UNITED STATES PATENT AND TRADEMARK OFFICE

APPLICATION NO.	FILING DATE	FIRST NAMED INVENTOR	ATTORNEY DOCKET NO.	CONFIRMATION NO.
10/671,842	09/25/2003	Michael D. Brookshire	121236.00003	9648

Office Action Summary

DETAILED ACTION

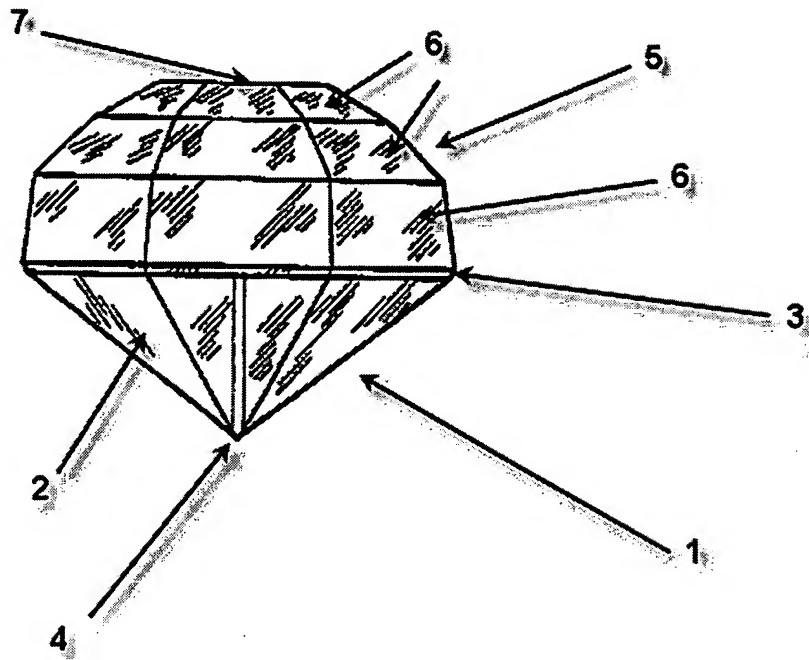
The shape and appearance of Stafford is identical in all material respects to that of the claimed design, *Hupp v. Siroflex of America Inc.*, 122 F.3d 1456, 43 USPQ2d 1887 (Fed. Cir. 1997).

As for Claim 1, Stafford teaches of a diamond (see figure below), comprising:

a pavilion (1) having a plurality of facets (2) disposed from a girdle (3) to a culet (4), each of plurality of facets (2) having a continuous flat surface extending from the girdle (3) to the culet (4), wherein an edge of a first adjoining facet (2) contacts an edge of a second adjoining facet (2) along a common radial boundary; and

a dome-shaped crown (5) disposed above the girdle (3), wherein the girdle (3) extends no further than a widest circumference of the dome-shaped crown (5) and the pavilion (1) extends no further than a widest circumference of the girdle (3), the dome-shaped crown (5) formed from a plurality of sets of facets (6) with an equal number of facets in each set, and the set of facets (6) cut with monotonically decreasing angles to form a stepped contour from the girdle (3) to an apex (7) of the dome-shaped crown (5), each of the sets of facets (2) having monotonically decreasing surface areas from the girdle (3) to the apex (7) of the dome-shaped crown (5).

As for Claim 13, Stafford teaches of a diamond (see figure above), comprising:

a pavilion (1) extending from a girdle (3) to a culet (4), wherein the girdle (3) extends no further than a widest circumference of the crown (5) and the pavilion (1) extends no further than a widest circumference of the girdle (3); and

a crown (5) in the form of a symmetrical hemisphere having a first set of facets (first 6) disposed above the girdle (3) and a second set of facets (second 6) disposed between the first set (first 6) of facets and an apex (7) of the crown (5), wherein the first set of facets (first 6) is cut at a first angle with respect to a reference line which is tangential to the apex (7) of the crown (5) and the second set of facets (second 6) is cut at a second angle with respect to the reference line

which is less than the first angle, each of the sets of facets (first and second 6) having an equal number of facets (6).

As for Claim 23, Stafford teaches of a diamond (see figure above), comprising:
a pavilion (1) having a plurality of facets (2) disposed from a girdle (3) to a culet (4); and
a dome-shaped crown (5) disposed above the girdle (3), wherein the girdle (3) extends no further than a widest circumference of the dome-shaped crown (5) and the pavilion (1) extends no further than a widest circumference of the girdle (3), the dome-shaped crown (5) formed from a plurality of sets of facets (6) with an equal number of facets (6) in each set, the dome-shaped crown (5) has a stepped contour from the girdle (3) to an apex (7) of the dome-shaped crown (5).
